## **Urgent Field Safety Notice**

### **Harrier Range Technical Manual**

**Invacare Ref: FSN 043**

### Replacing the drive wheel.

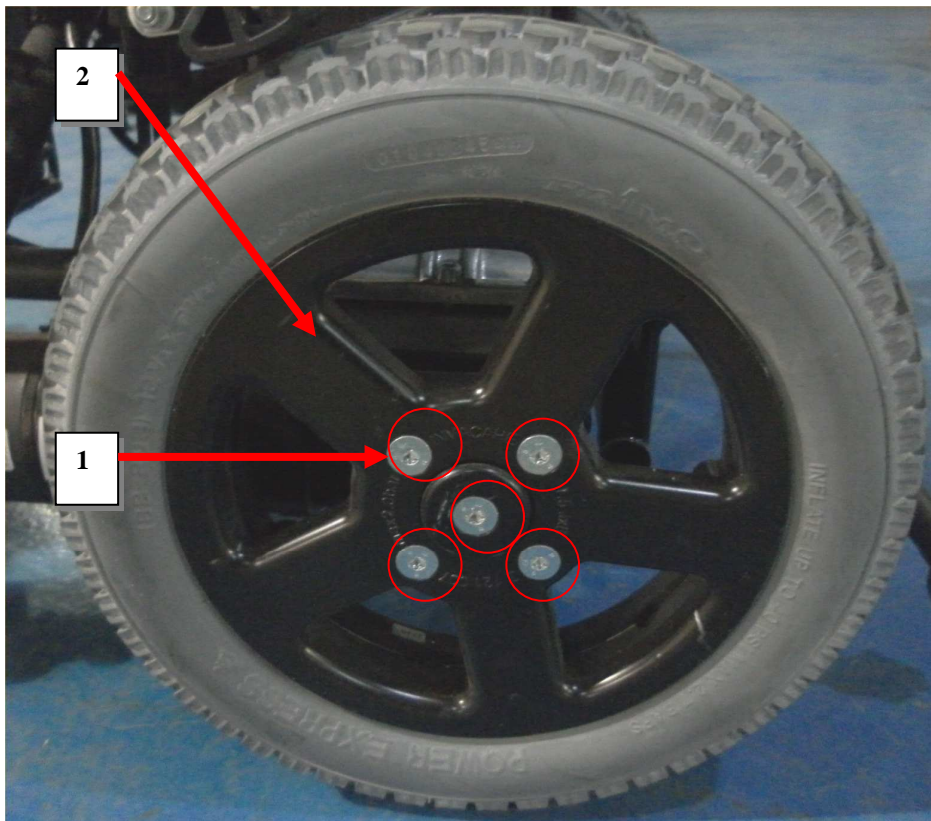
A review and update of the service / maintenance instructions within the Technical Manual will be completed following notification that there was insufficient information for the correct removal and refitting of the drive wheel.

The amended procedure is attached below. This information will be included in the amended version of the Technical Manual which will be available on Invacare website from 1<sup>st</sup> June 2012.

- Lift the mobility aid up on one side and get a second person to place a suitably sized wooden block underneath it so that the drive wheel is suspended freely.
- Loosen the five T40 Torx Screws (1).

- Take the wheel (2) off the hub.

- Re-fit the drive wheel in reverse order.
- Please ensure the wheel is re-fitted on the same side and is in the same running direction as removed.
- When re-fitting the Torx screws ensure the correct tightening torque as per the table below is applied.

Note: When re-fitting the drive wheel ensure new \*T40 M8 x 25mm Torx screws with Loctite patch are used. Part No 1496138

All removed fasteners must be replaced with new items.
